SUBMISSION

DIANE SOMERVILLE, owner of UNIT 5, 139 PACIFIC PARADE DEE WHY
PO Box 1458, Dee Why NSW 2099

RE: DA 2025/0024
158 PACIFIC PARADE DEE WHY NSW 2099
WRITTEN SUBMISSION: LETTER OF OBJECTION
SUBMISSION: TULLOCH on behalf of SOMERVILLE

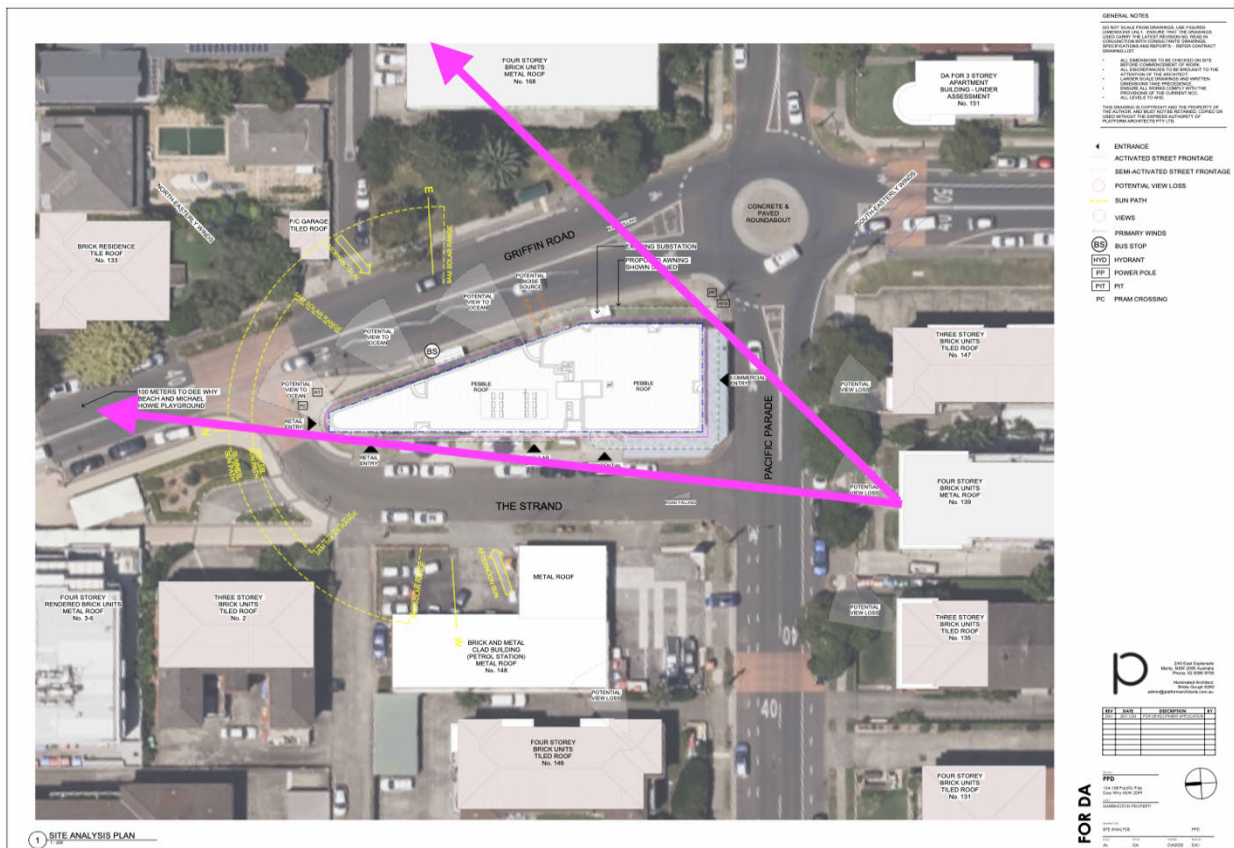
I contend, that the excessive HOB beyond the LEP provisions causes:

- **Severe & Devastating View Loss Outcomes** from multiple units surrounding the subject site, including my client's unit which directly faces the site
- **Unacceptable Streetscape** outcomes proposing 14.9m HOB building in a 11.0m LEP HOB Zone, with the full non-compliant heights being viewable from all key areas of Dee Why Beach

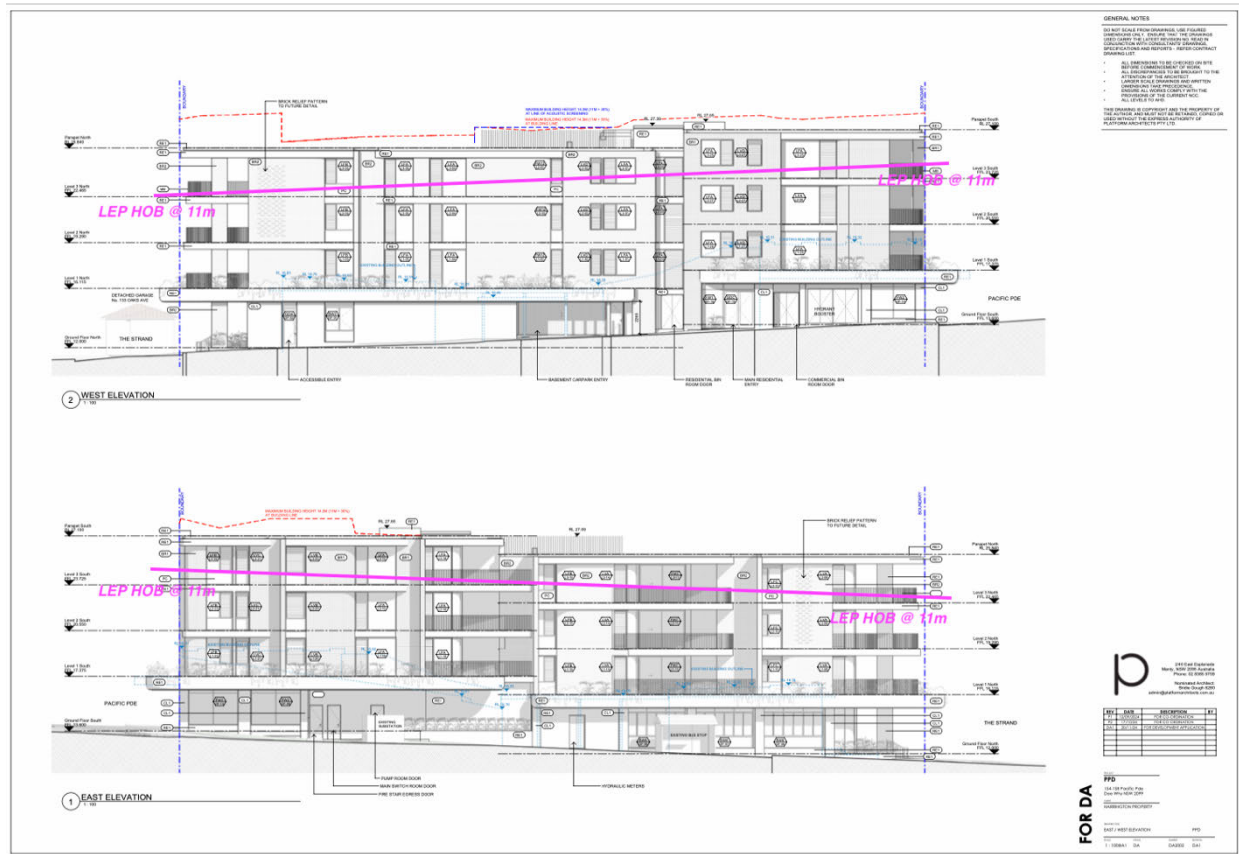
Council will note:

- LIFT OVER-RUN @ RL 27.6
- SURVEY HEIGHT to the north of the existing substation at the boundary @ RL 12.7
- HOB 14.9m

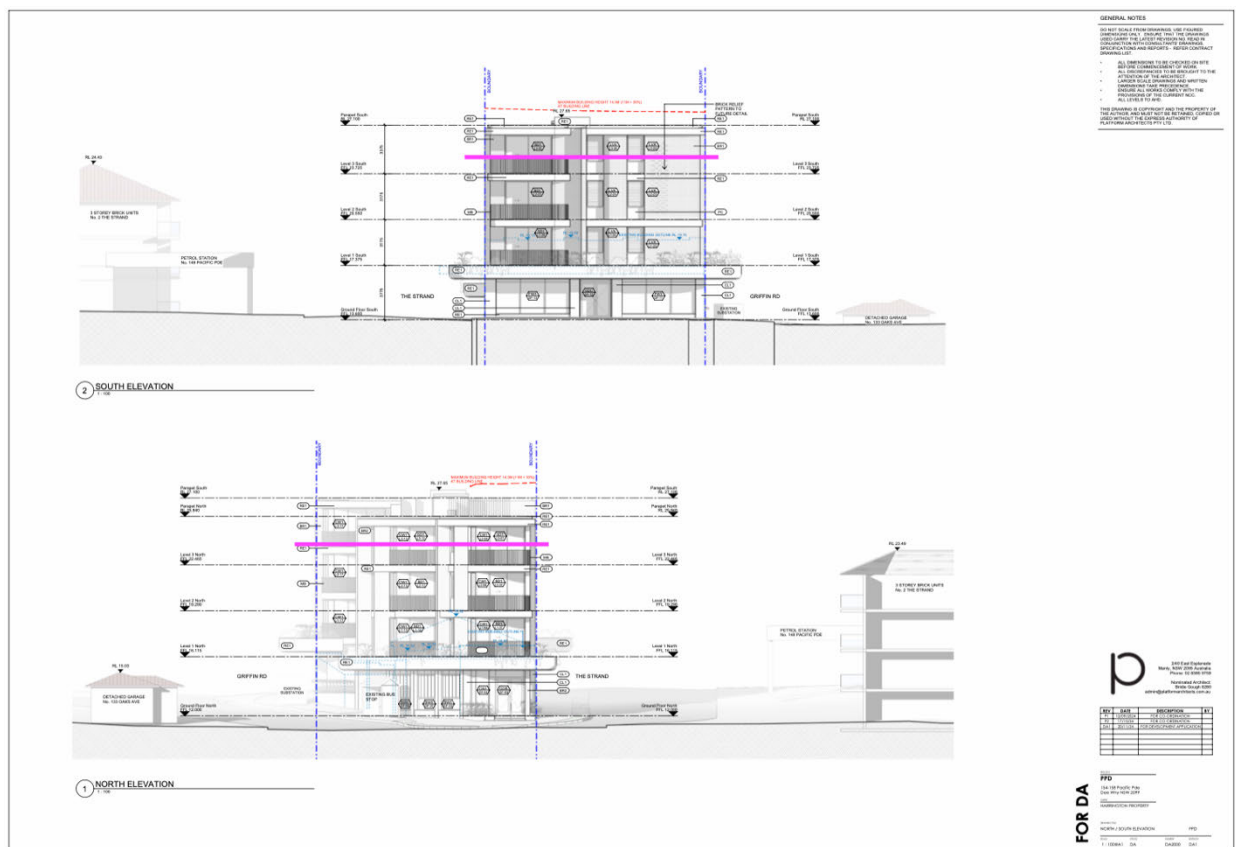
The excessive HOB exceeding LEP standards.

- EXCESSIVE BUILDING HEIGHT [LEP HOB]: Proposed 14.9m v Control 11.0m [35% non-compliance]
- EXCESSIVE BUILDING HEIGHT [SEPP 30% BONUS HOB]: Proposed 14.9m v Control 14.3m [4% non-compliance]
